CASE # 2010-COA-139 (WP) Part B	INDIANAPOLIS HISTORIC PRESERVATION COMMISSION STAFF REPORT	Hearing Date SEPT. 7, 2011
1831 Woodruff Place Cross Drive WOODRUFF PLACE		<i>Continued case: Aug. 3, 2011 July 6, 2011 May 4, 2011</i>
Applicant: KEVIN BETTS	mailing address: 645 East 54th Street Indianapolis, IN 46220	
Owner: Same as above		Center Township Council District: 16 Brian Mahern
CASE		
IHPC COA: 2010-COA-139 (WP) Part B	Construct a rear porte-cochere structure.	
STAFF RECOMMENDATION: Approval with Stipulations

Rear Porte-Cochere Structure

Photo taken c.1900 showing east side of house before a house was built next door. Note the edge of the rear porch (now gone).

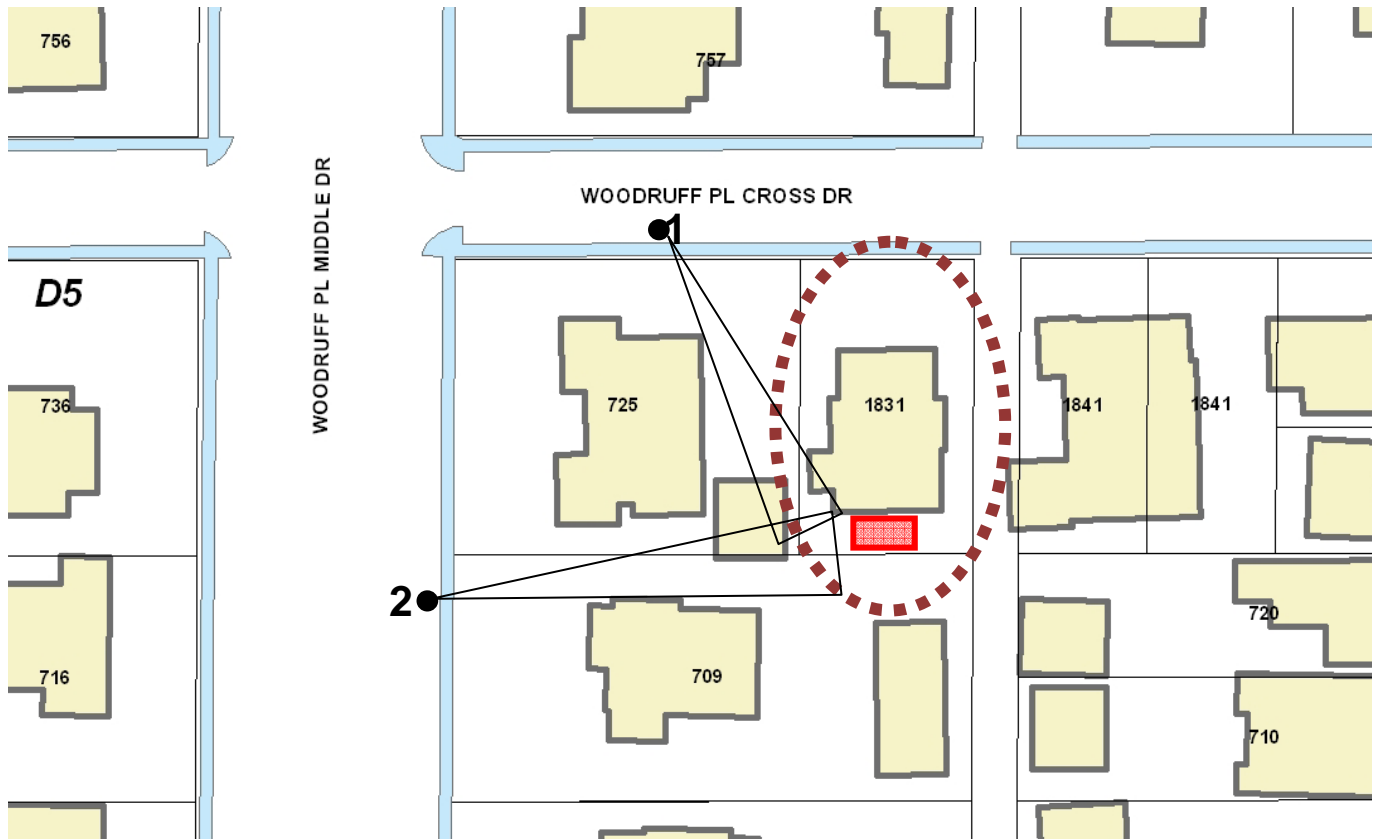
2. The porte-cochere will be at the back of the house and would be minimally visible from Cross Drive or Middle Drive. This is consistent with the Woodruff Place Preservation Plan's recommendation that the new additions "...*should be located at the rear, away from the front façade.*"

3. The design, detailing and materials are all reflective of the house's architecture.
4. The location is similar to the original rear porch.
5. This property is too small to comfortably accommodate a detached garage.

South Elevation

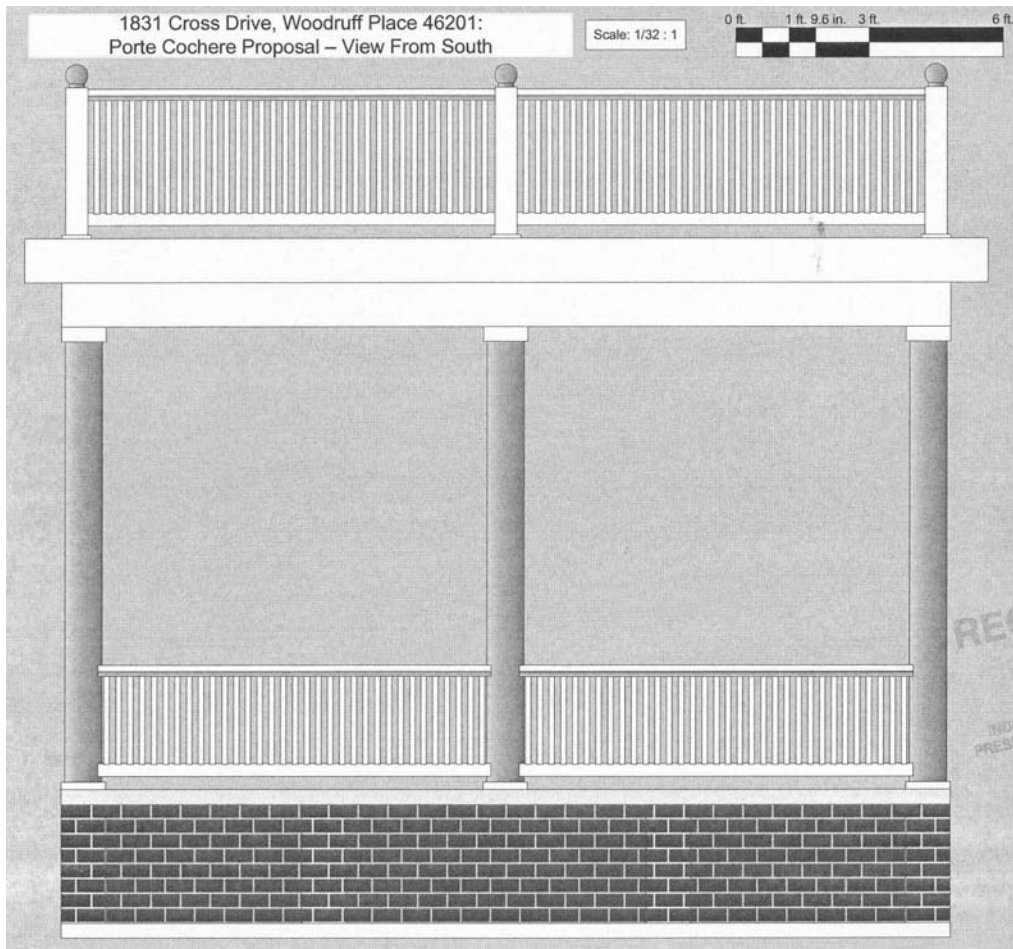
The porte-cochere is designed with a low brick wall base along the south side of the structure and two separate piers all with concrete caps. A total of five wood columns sit on top of the masonry structure and hold up the flat roof structure with a second floor wood balustrade and wood floor surfacing material. The existing second floor rear window configuration is expected to remain.

Indiana Landmarks, which has a covenant on the property, and the Woodruff Place Civic League (WPCL) both object to this porte-cochere, as designed. They have met with Mr. Betts, but no compromise has been reached. There appear to be two major objections:

1. Opposition to the balustrade around the roof of the porte-cochere
 - a) Indiana Landmarks objects to adding a detail that was not found on the original porch (now long-gone) because it will confuse people regarding what is original and what is new. Indiana Landmarks believes that removing the balustrade will make the porte-cochere more contemporary and read as a new addition.
 - b) The WPCL does not want Mr. Betts to use the roof of the porte-cochere as an outdoor porch-like space, so they oppose the balustrade around the edge of the porte-cochere's roof, in order to discourage use of the roof for an outdoor porch/deck.

Staff Thoughts: The Woodruff Place Plan neither prohibits nor encourages second floor porches and/or balustrades on porch roofs. Staff sees this as a case-by-case design issue. The IHPC has approved many second floor porches over the years. The IHPC has approved many porches with balustrades. Staff finds the balustrade, as depicted in the drawings, to be simple and not overly "historicized." Staff finds this balustrade very similar to others approved in the past. Regarding the potential access to the roof of the porte-cochere, staff has not been able to articulate a preservation reason for denying a balustrade simply because the owner might walk onto the roof.

To approve a Certificate of Appropriateness to build a rear porte-cochere; all per submitted documentation and subject to the following stipulations:

- 1. Porte-cochere must be field-staked, with no offsets, and reviewed by IHPC staff prior to commencement of work. Approved: _____ Date: _____**
- 2. Final construction drawings must be submitted to IHPC staff for final approval. Approved _____ Date _____**
- 3. No changes to the proposed design, location, configuration, or method of installation are permitted without prior consultation with IHPC staff.**
